Proposed Revisions to a Standard Plans Index

Index Number: 654-001

Index Title: Rectangular Rapid Flashing Beacon Assembly

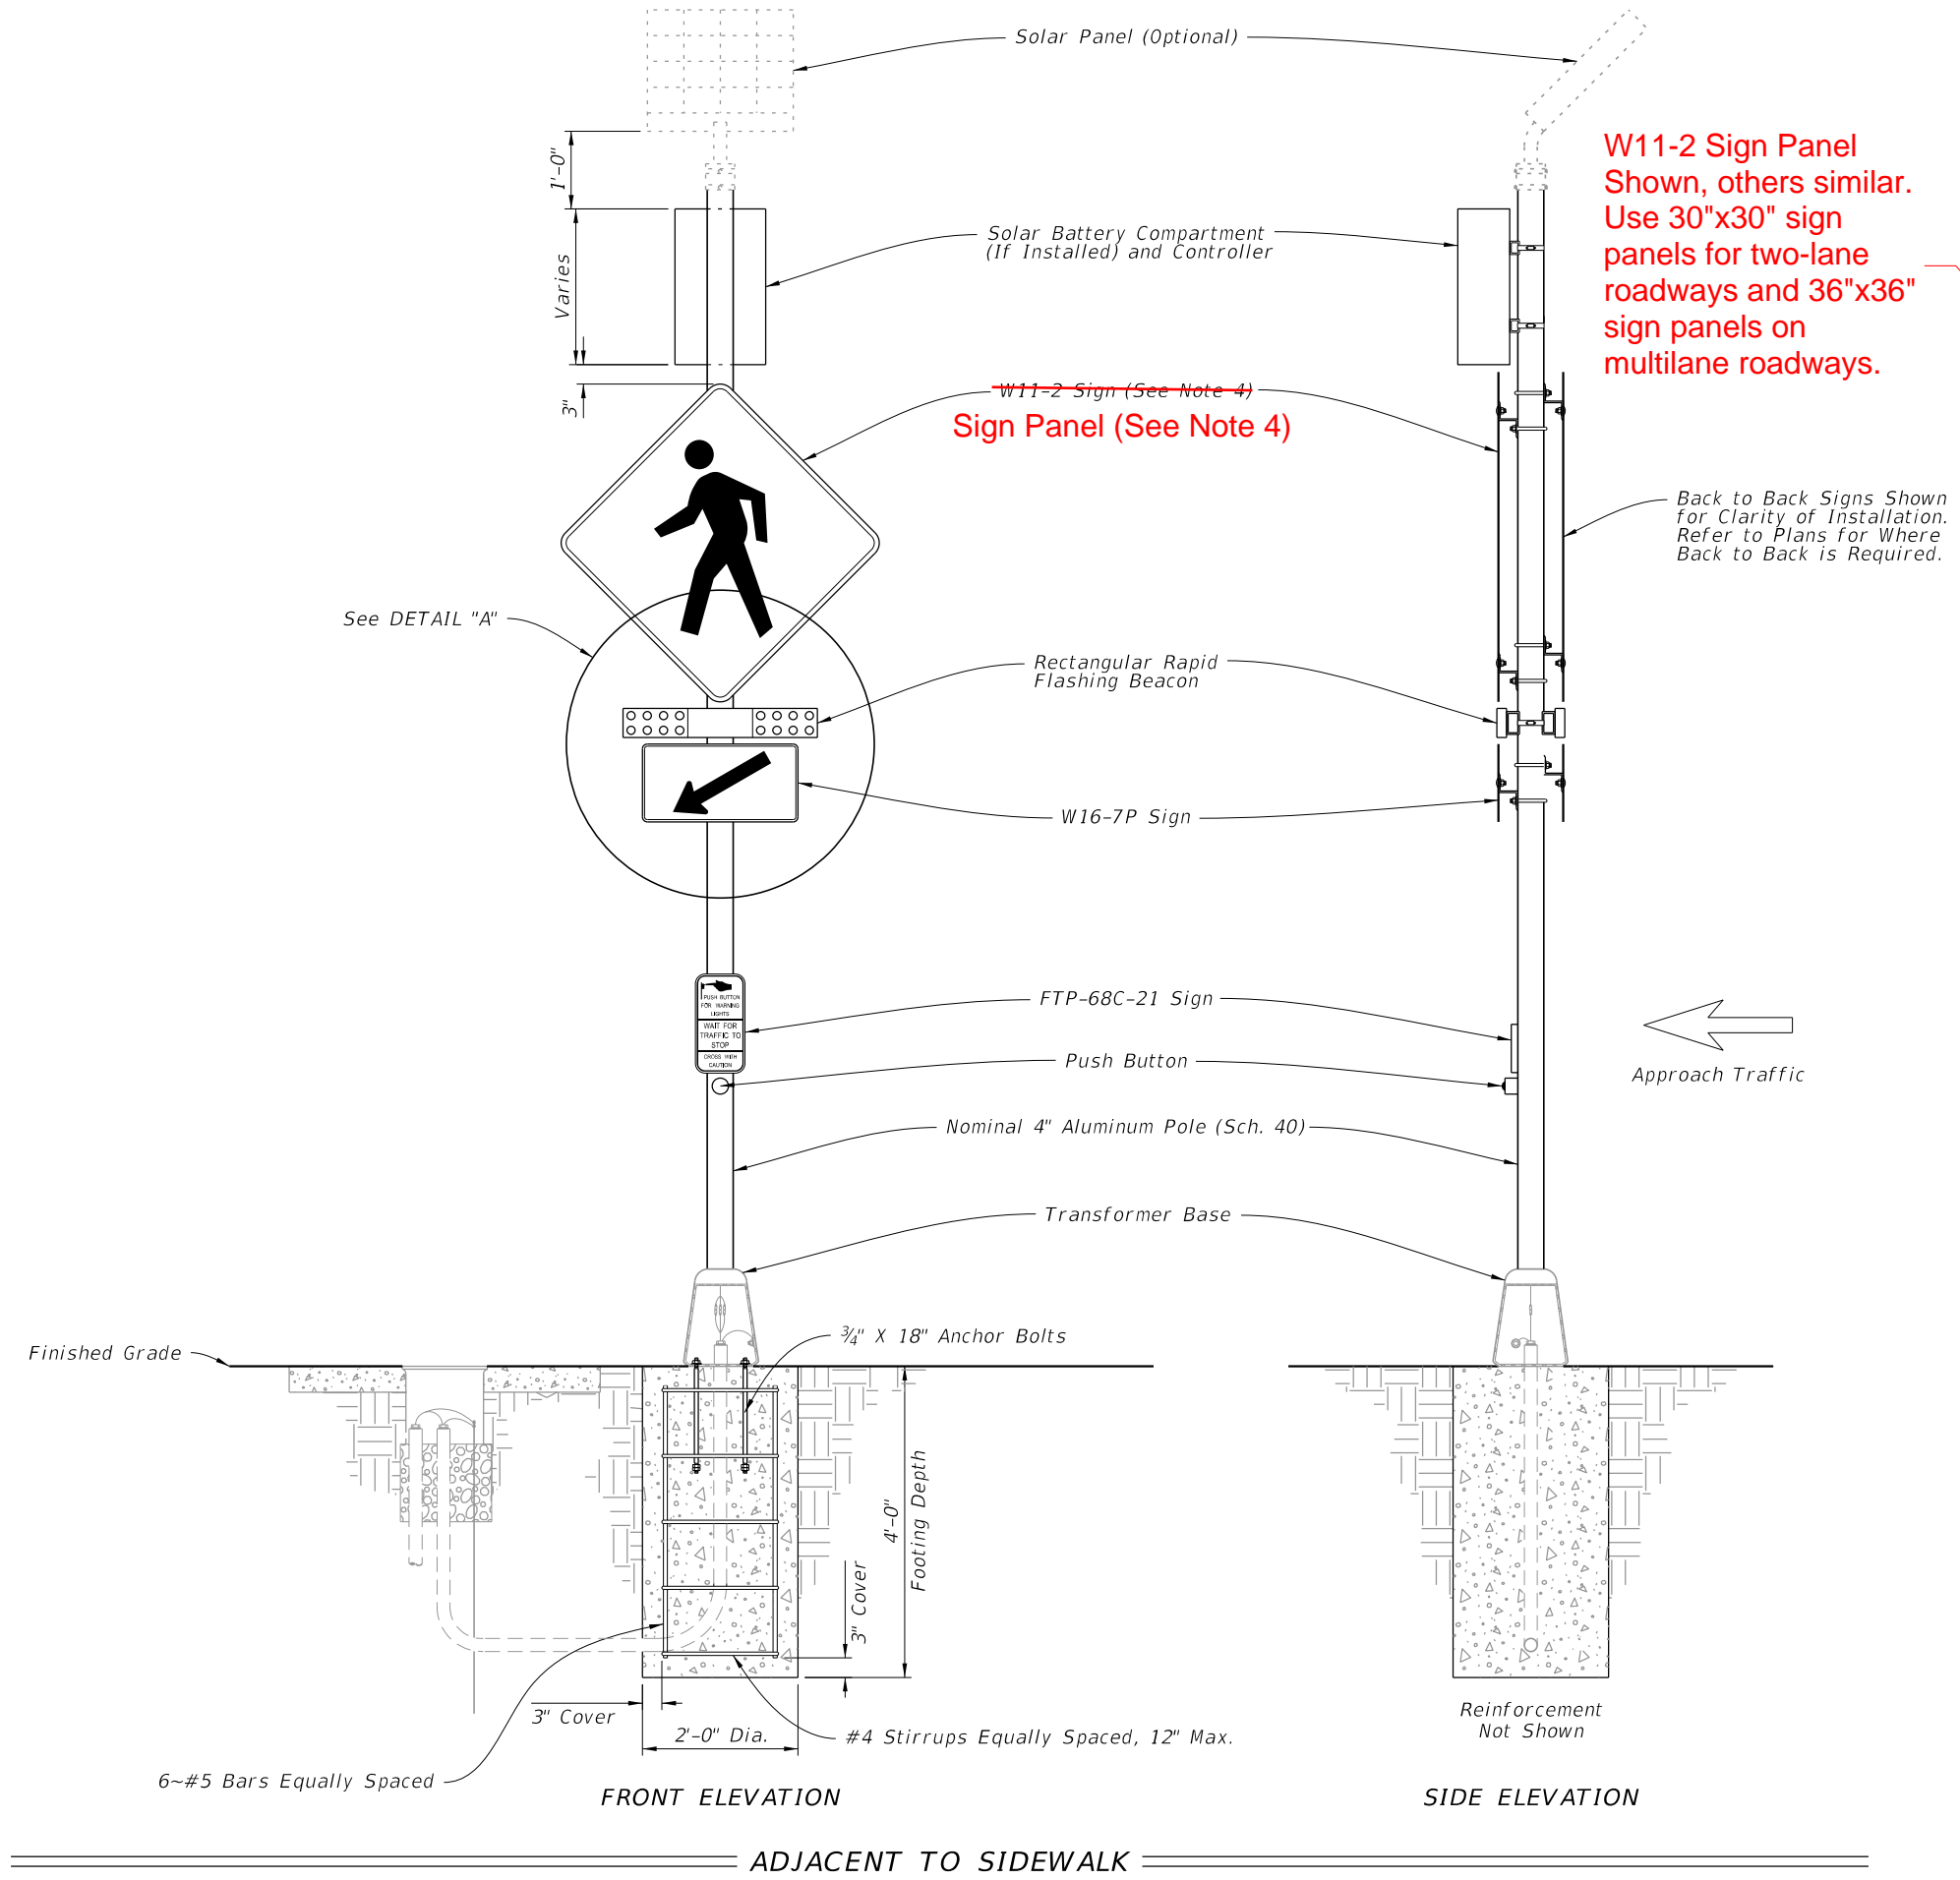
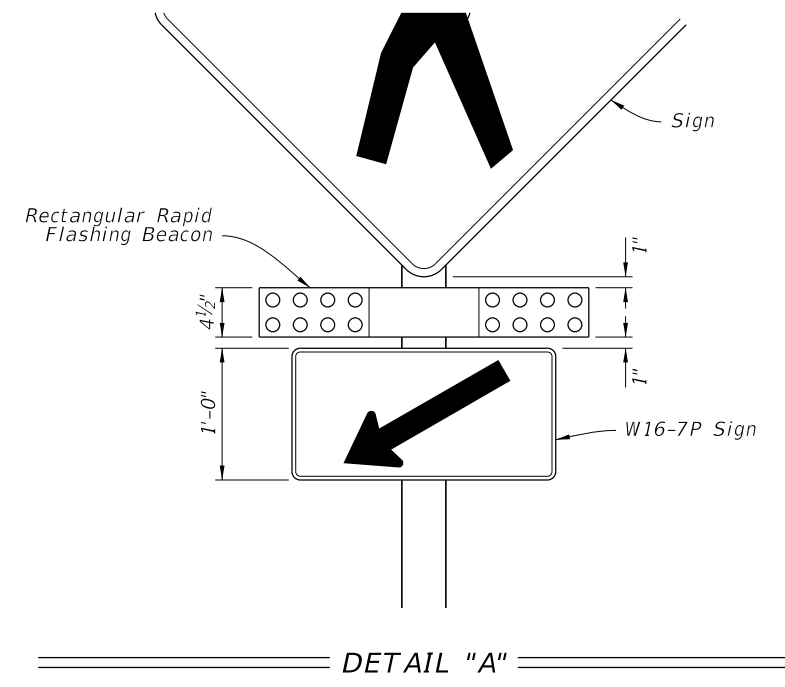
Sheet 1: Updated Note 4 to "W11-2 Sign Panel Shown, others similar. Use 30"x30" sign panels for two-lane roadways and 36"x36" sign panels on multi-lane roadways. Updated callout to "Sign Panel (See Note 4)". Added Note 12, "In lieu of footing design shown, a Spread Footing may be used in accordance with index 700-120."

W11-2 Sign Panel
Shown, others similar.
Use 30"x30" sign
panels for two-lane
roadways and 36"x36"
sign panels on
multilane roadways.

2. Install the RRFB in pairs, one on either side of approach traffic.
 3. Install controller on the backside of post from approach traffic.
 4. ~~Install a 30" X 30" W11-2 sign on two-lane roadways and a 36" X 36" W11-2 sign for multilane roadways.~~

12. In lieu of footing design shown, a Spread Footing may be used in accordance with Index 700-120.

Note 4 and callouts were updated at the request of the TERL to allow for various sign options.

Note 12 was added because of new spread footing design option in Standard Plans Index 700-120.

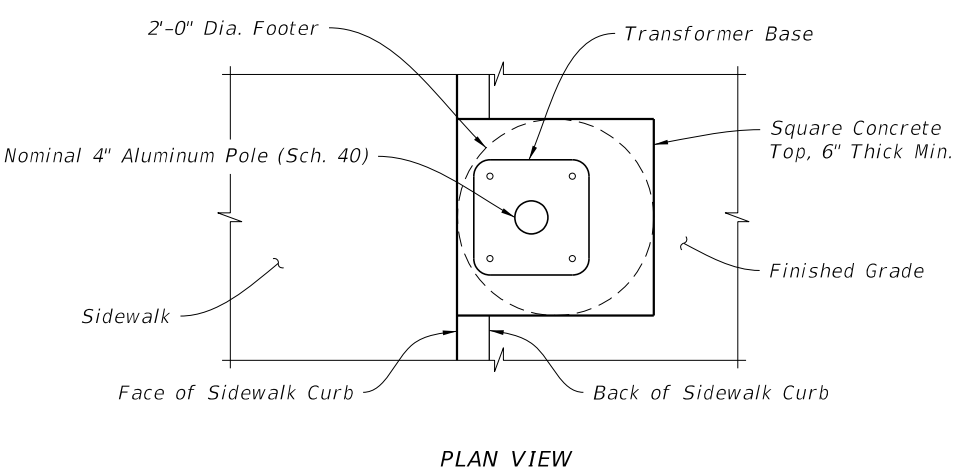
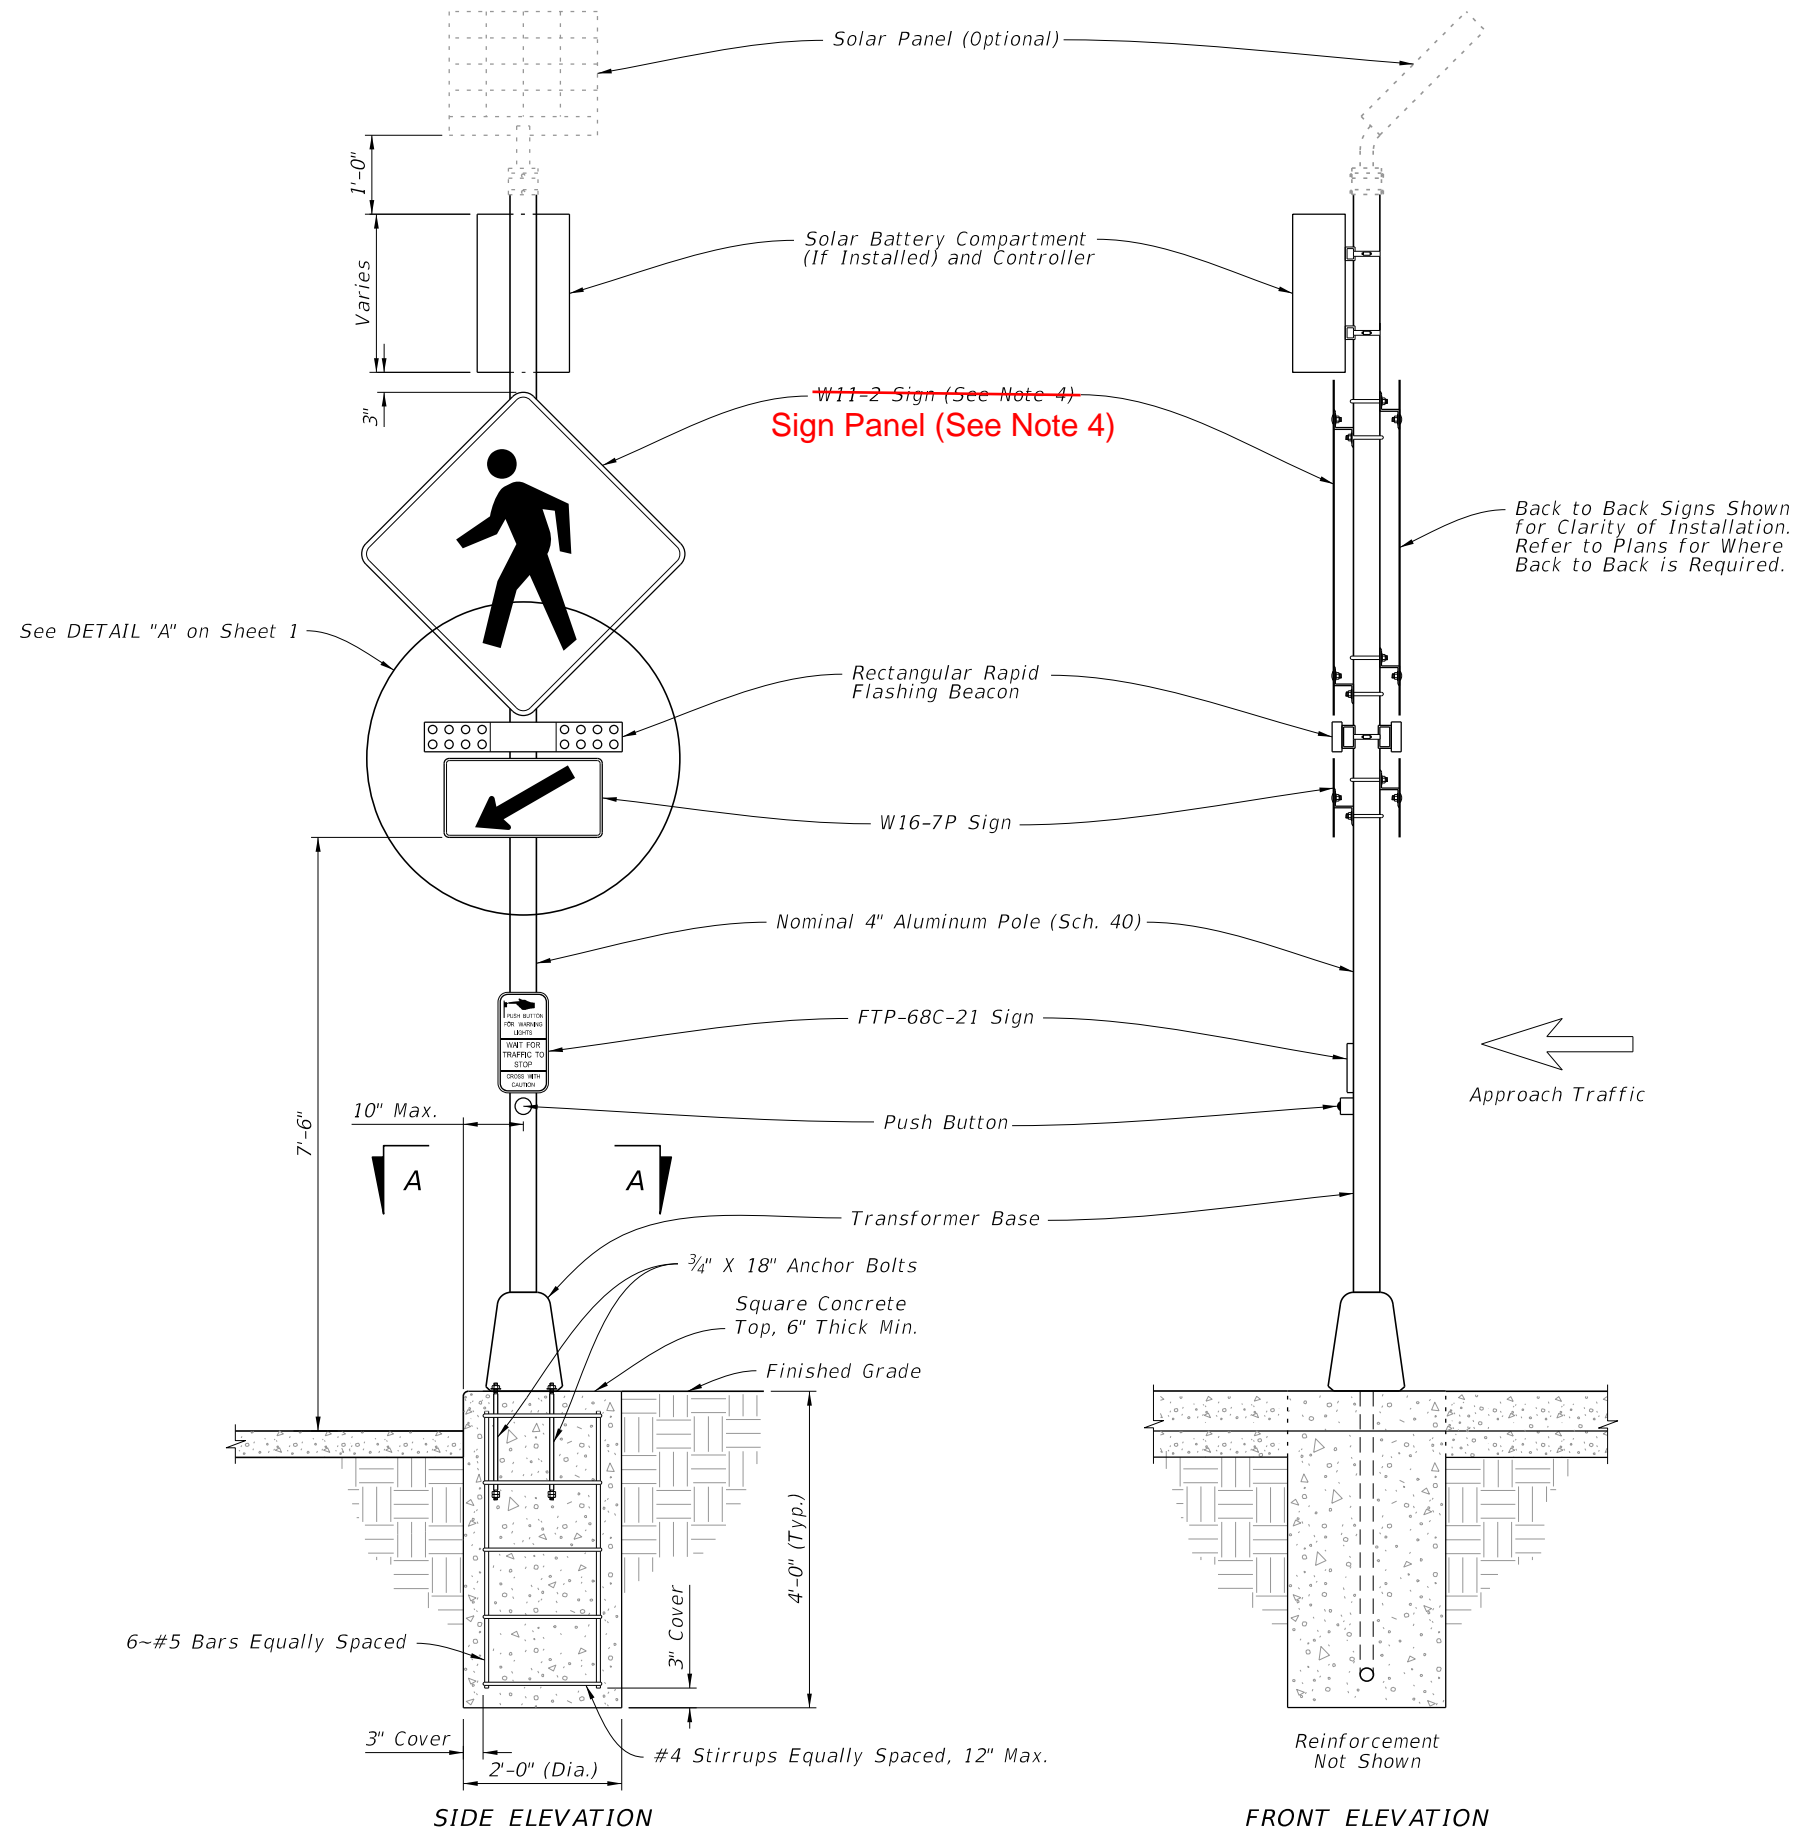
Sheet 2: Updated callout to "Sign Panel (See Note 4)".
